24590-LAW-PCN-ENV-19-008

**Hanford Facility RCRA Permit Modification Notification Form**  
**Part III, Operating Unit 10**  
**Waste Treatment and Immobilization Plant**

Modification to the Hanford Site RCRA / WTP Dangerous Waste Permit consisting of updates to Piping and Instrumentation Diagrams for the LAW Melter Feed Process System (LFP), LAW Secondary Offgas / Vessel Vent Process System (LVP), and Radioactive Liquid Waste Disposal System (RLD). Updates performed are in accordance to WAC 173-303-830, Appendix I Modification citation number: A.3., equipment replacement or upgrading with functionality equivalent components (e.g., pipes, valves, pumps, conveyors, controls).

The purpose of this Class <sup>1</sup> modification is to provide Piping and Instrumentation Diagrams (P&IDs) for the LAW Melter Feed Process System (LFP), LAW Secondary Offgas/Vessel Vent Process System (LVP), and Radioactive Liquid Waste Disposal System (RLD) for incorporation into Appendix 9.2 of the WTP RCRA permit:

CONTRACT No.: DE-AC27-01R14136  
**P&ID - LAW  
 LAW MELTER FEED  
 PROCESS SYSTEM  
 MELTER 2 FEED VESSEL  
 LFP-VSL-00004**  
 24590-LAW-M6-LFP-00003004

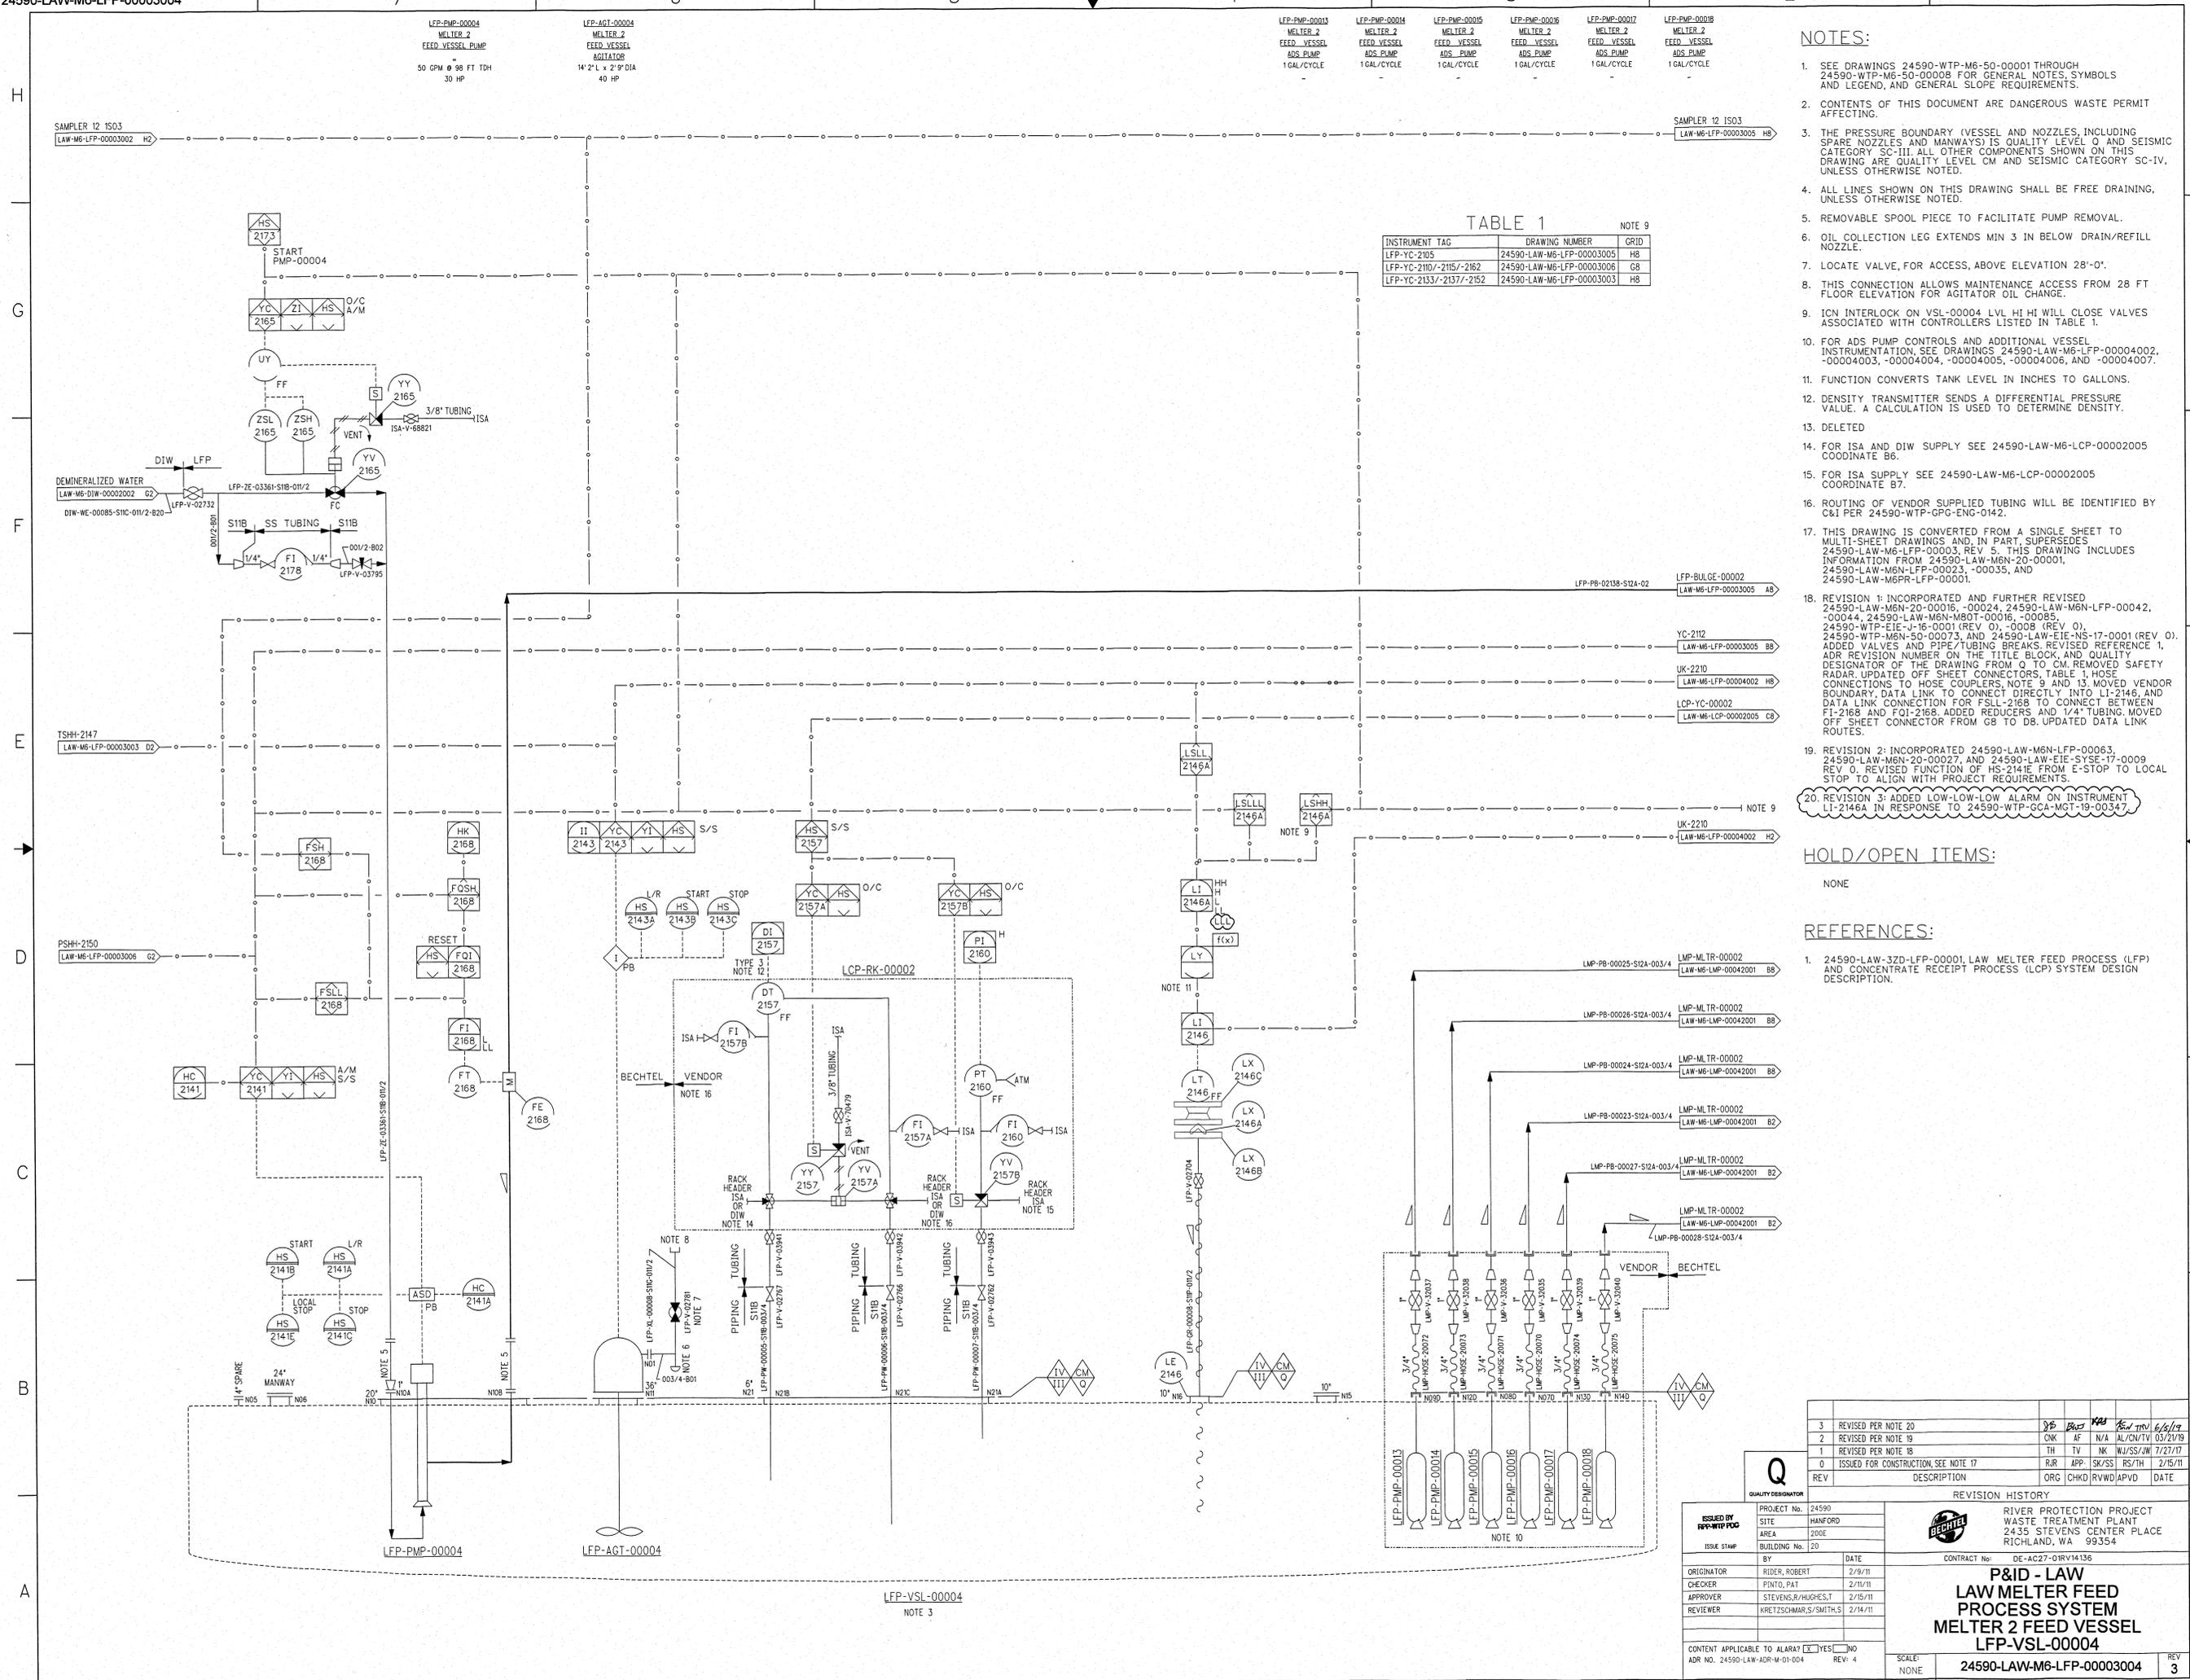
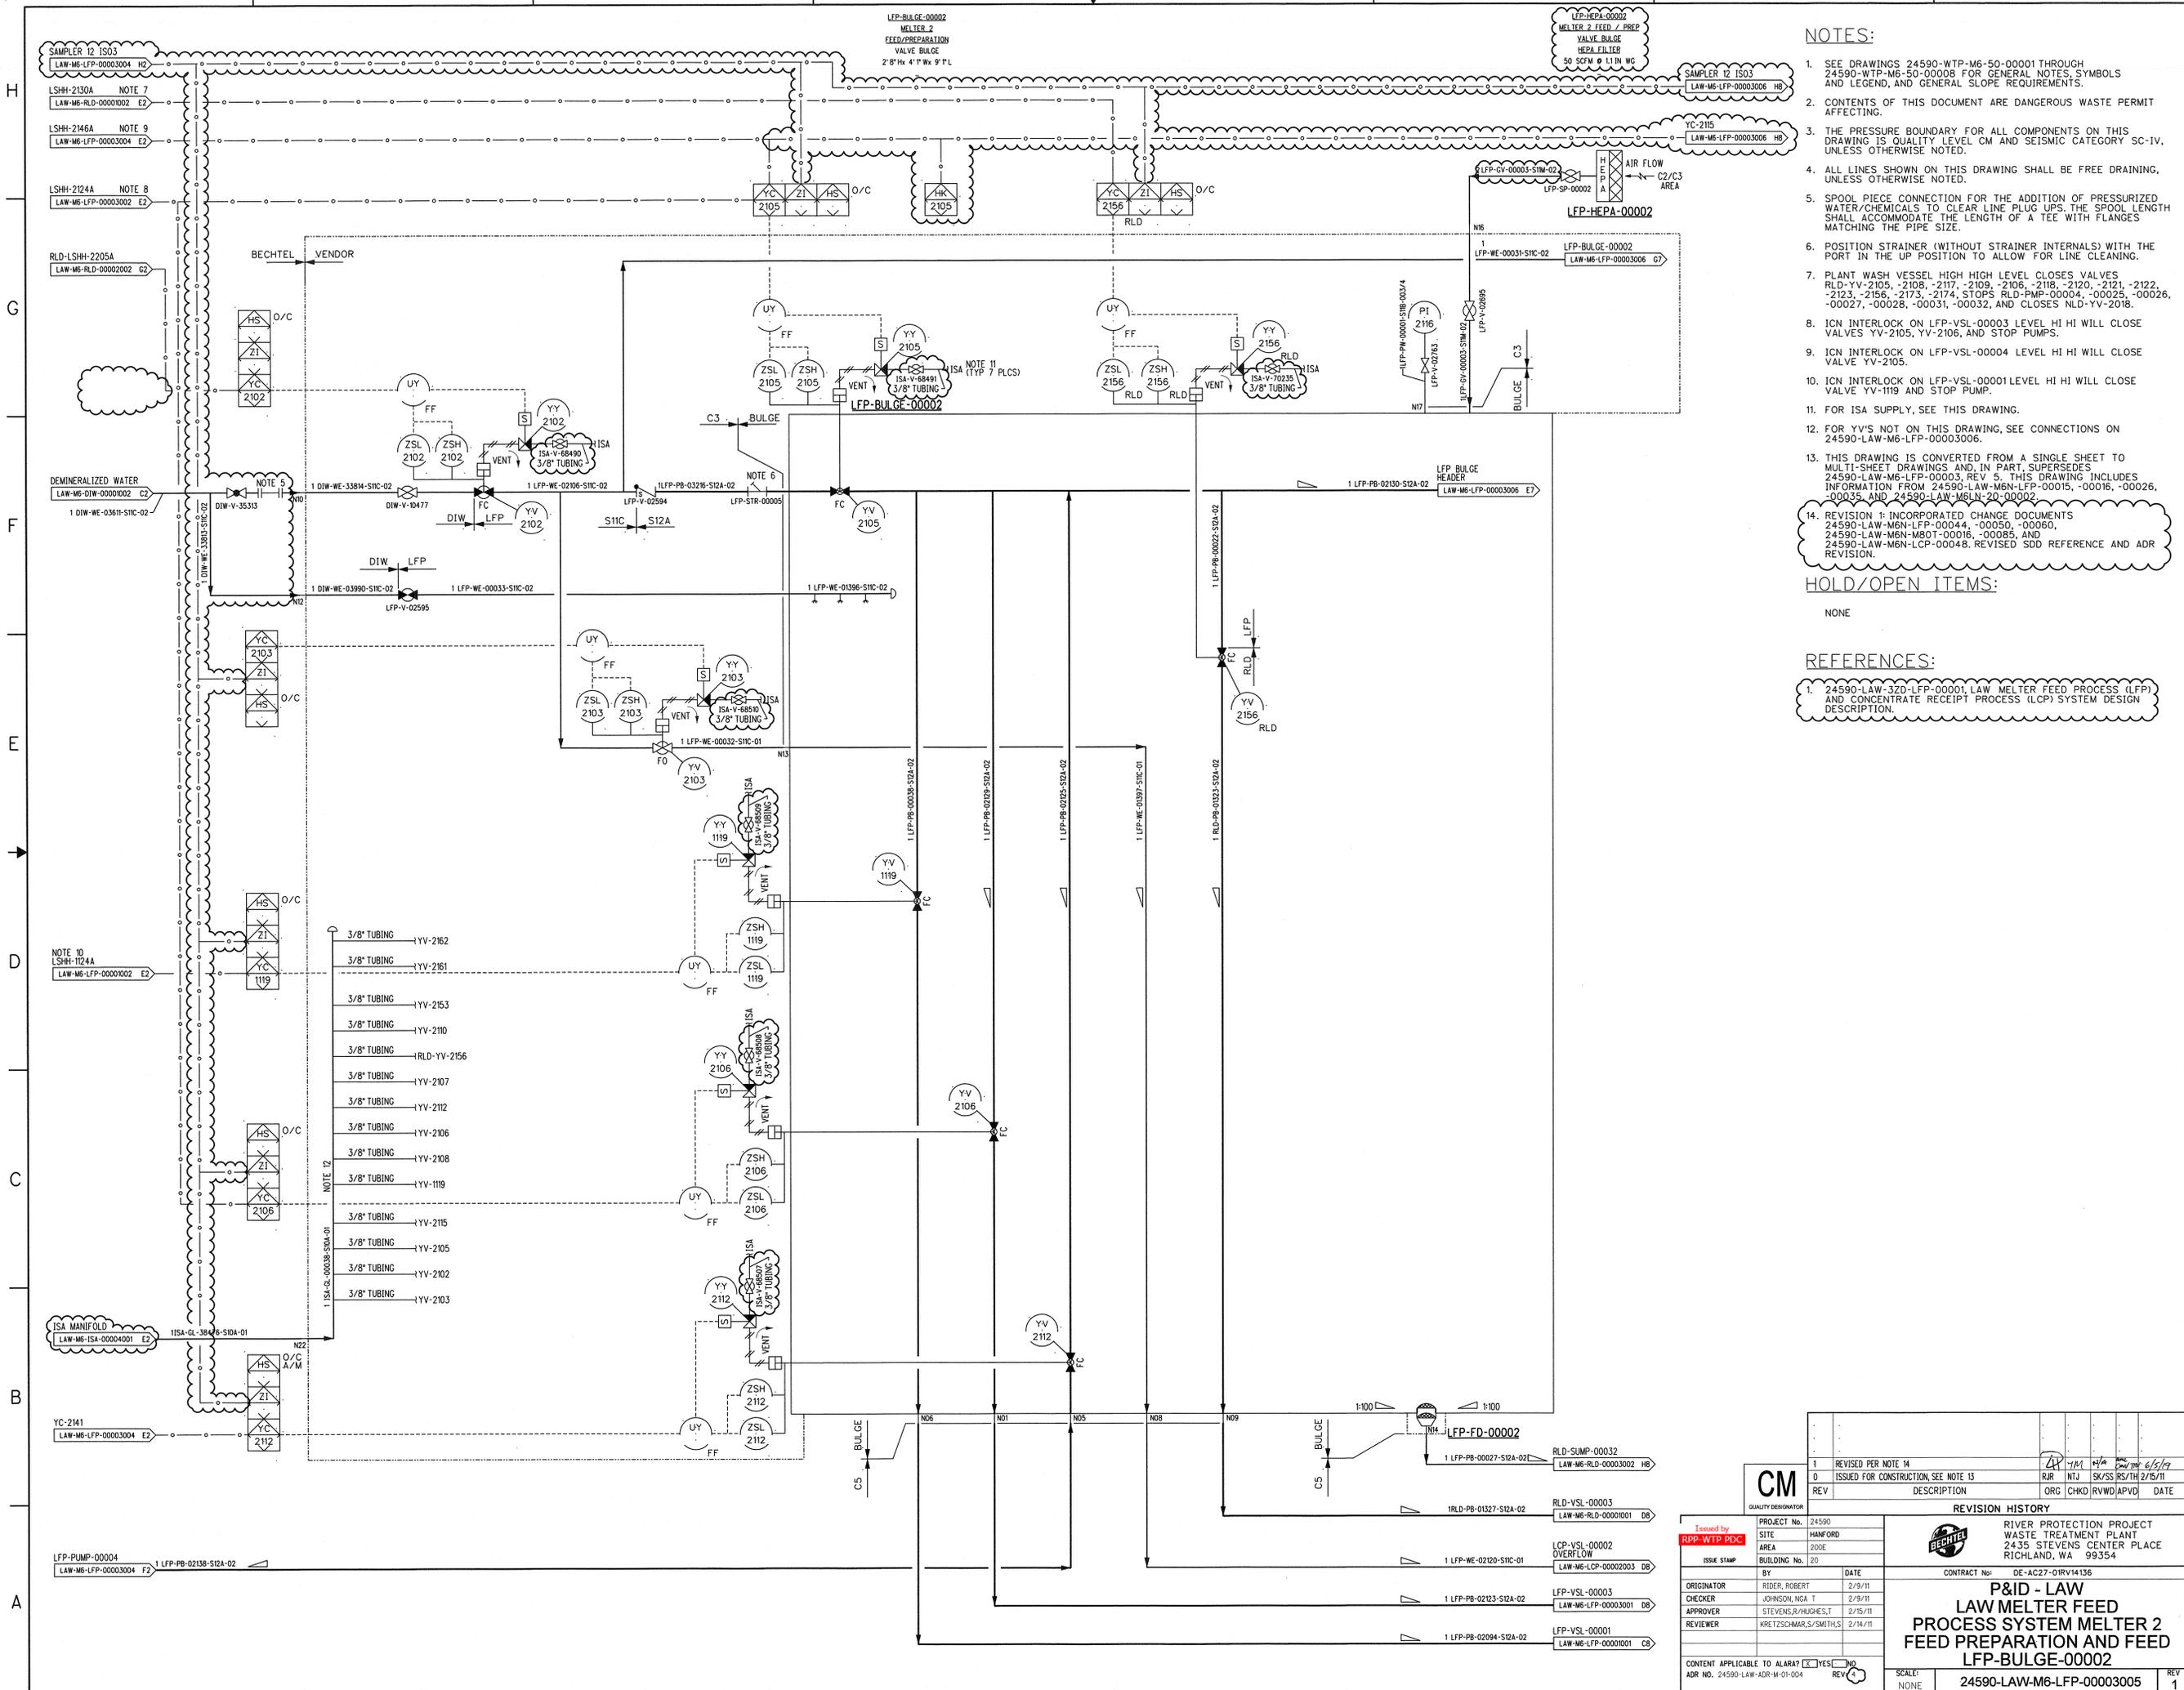
5. Significant changes incorporated into the Piping and Instrumentation Diagram (24590-LAW-M6-LFP-00003004, Rev. 3) for Melter 2 Feed Preparation Vessel LFP-VSL-00004 of the LAW Melter Feed Process System are summarized below.

- a. Addition of Note 19, specifies function of HS-214E from E-stop to local stop, aligning with project requirements, added in Rev. 2 of 24590-LAW-M6-LFP-00003004.

- b. Addition of Note 20, specifies the addition of Low-Low alarm on instrument LI02146A in response to 24590-WTP-GCA-MGT-19-00347 in Rev. 3 of 24590-LAW-M6-LFP-00003004.

- REVISION 2: INCORPORATED 24590-LAW-M6N-LFP-00063, 24590-LAW-M6N-20-00027, AND 24590-LAW-EIE-SYSE-17-0009 REV 0. REVISED FUNCTION OF HS-2141E FROM E-STOP TO LOCAL STOP TO ALIGN WITH PROJECT REQUIREMENTS.

- REVISION 3: ADDED LOW-LOW-LOW ALARM ON INSTRUMENT LI-2146A IN RESPONSE TO 24590-WTP-GCA-MGT-19-00347.
